Process Sheet

Drawing Name : REWORK

Part Number : D350636011
 Drawing Number : ECN1191
 Project Number :
 Drawing Revision :
 Material :
 Due Date : 22/05/2008

DART SERVICE INSTRUCTION

FIGURE 1 - D350-636-011/-012/-013/-014 AT CHG 004 AND INSTALLATION OF DSI 9413-011
(LOCATION OF AN526C1032RXX SCREWS ARE NOT TO BE USED TO MOUNT WEARSHOES)

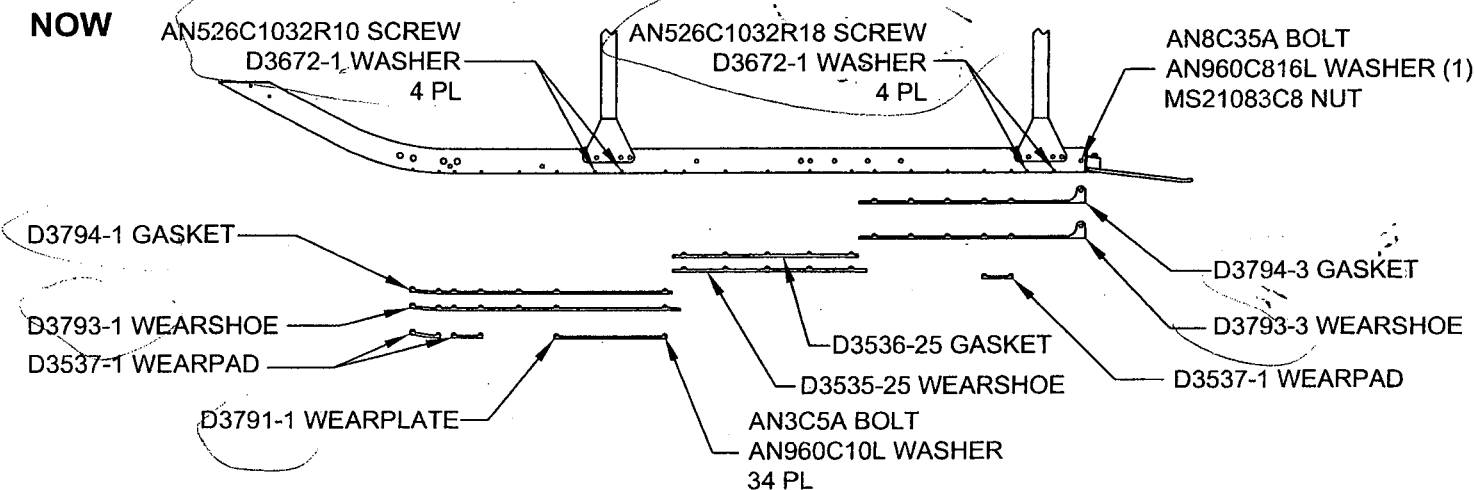
TO IMPROVE THE INSTALLATION OF THE DART D350-636-011/-012/-013/-014 SKIDTUBES ONTO THE CROSSTUBES, THE INSTALLATION AND PART NUMBERS OF THE FWD AND AFT WEARSHOES/GASKETS HAVE BEEN REVISED AS SHOWN IN FIGURE 1 BELOW.

WAS

NOW

ADD TO FRONT OF TUBE PER DRWG DSI9413 REV.A

ADD TO BACK OF TUBE PER DRWG DSI9413 REV.A
